ALERT SERVICE LETTER

Subject: Non-Rotating Cargo Hook Suspension System Interference

Helicopters Affected: Bell Helicopter 412EP, 412HP and 412SP

Document: 159-041-00

Image 1: Reported Contact Area

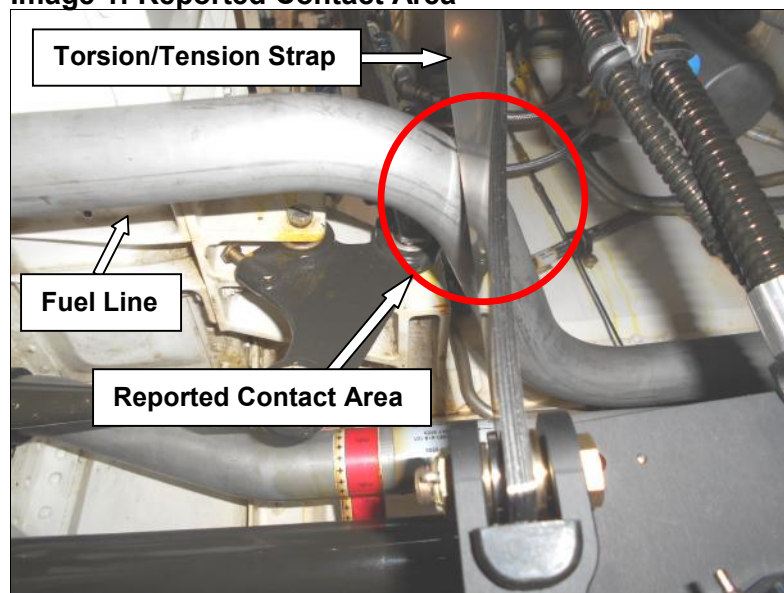
Description: Onboard Systems has received a report of contact between the cargo hook suspension system torsion/tension strap and a fuel line routed through the hook well on a Bell 412EP. This was discovered during the initial installation of the system and did not lead to any incident. See image below.

- 1) **Perform the installation check-out procedure.** Verify the cargo hook suspension system will pass the check-out procedure outlined in Owner's Manual 120-145-00, Section 4.4, Paragraph 2. This procedure calls for moving the cargo hook suspension system throughout its entire range of motion and ensuring it does not contact any adjacent equipment mounted in the hook well. Pay particular attention for any contact between the suspension system torsion/tension straps and any fuel lines routed through the area.
- 2) If there is any contact between the suspension system and any adjacent equipment, including fuel lines, immediately remove the cargo hook suspension system from service and contact Onboard Systems for further guidance.
- 3) If there is no contact between the suspension system and any adjacent equipment, no further action is required.
